**From:** Keenan, Gina N - DNR  
**Sent:** Tuesday, July 17, 2018 3:15 PM  
**To:** 'Ron Anderson'  
**Subject:** Arlene's Inn  
**Attachments:** 20180717151245659.pdf

Figure 2  
 Ground Water Flow Map  
 (Water Table Wells 6/27/07)  
 Arlene's Inn  
 Willard, Wisconsin

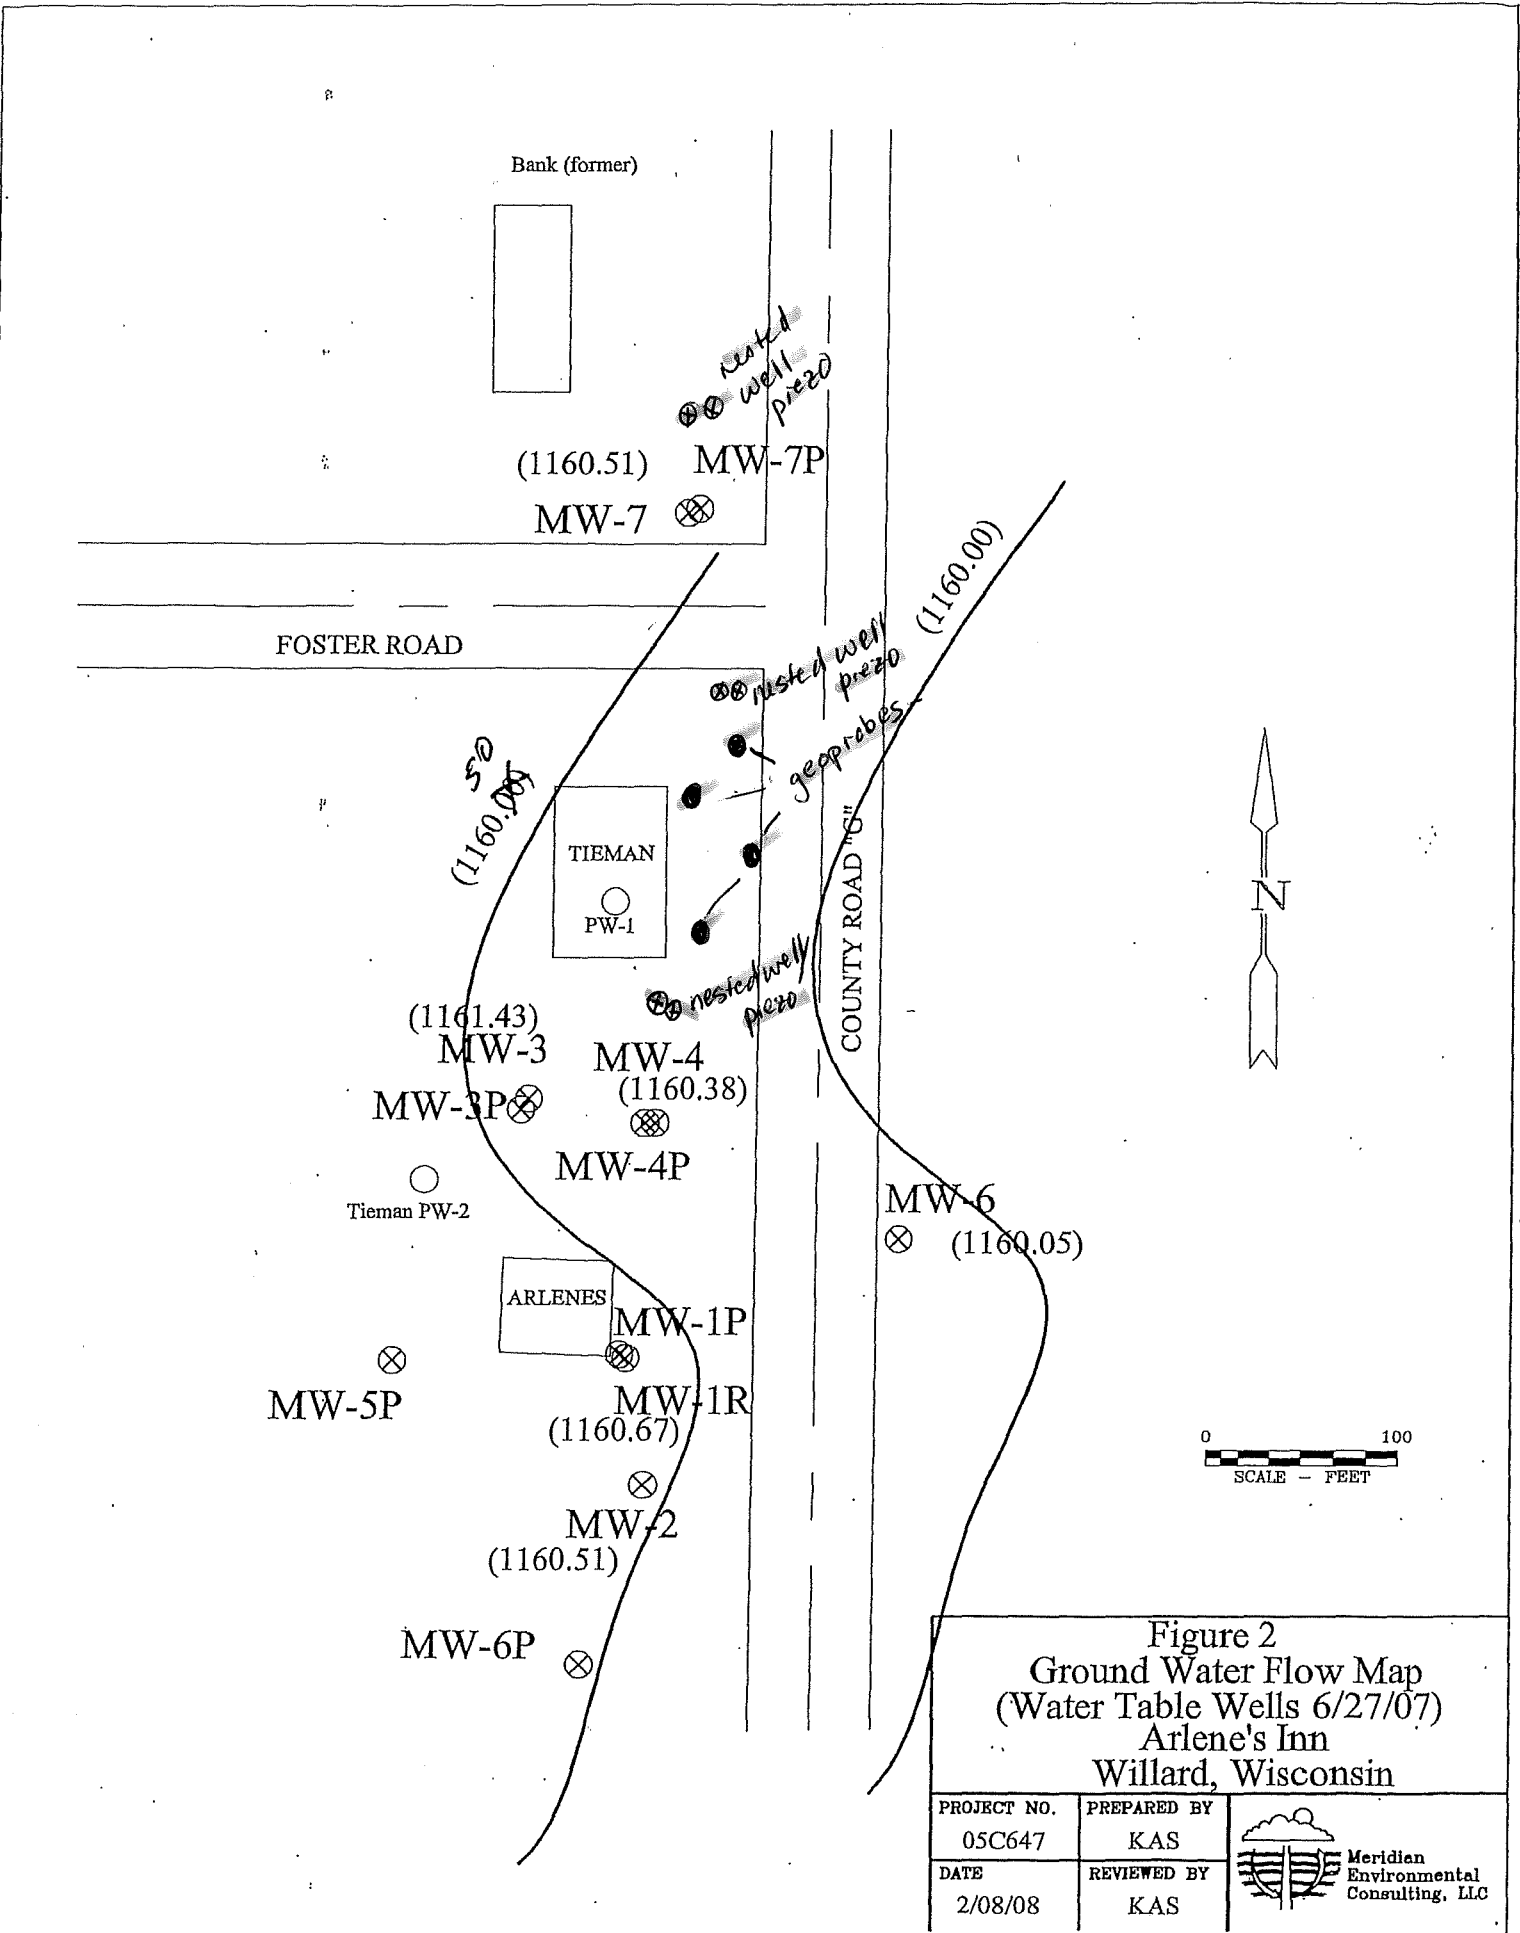
- replace the potable well at the former Tieman's site per the conditional closure letter for Arlene's -install 4 geoprobes at the locations marked on the attached map. Collect two soil samples per boring one in the direct contact zone and the other within the zone where field evidence indicates the most contamination present.
- installation of three nested monitoring wells/piezos in the areas designated on the attached map.
- collection of two, quarterly rounds of groundwater samples from the nested wells.

If you need to change locations for the borings and wells/piezos or think there are better locations, give me a call to discuss. I will forward you the last two reports at the site via email for your reference.
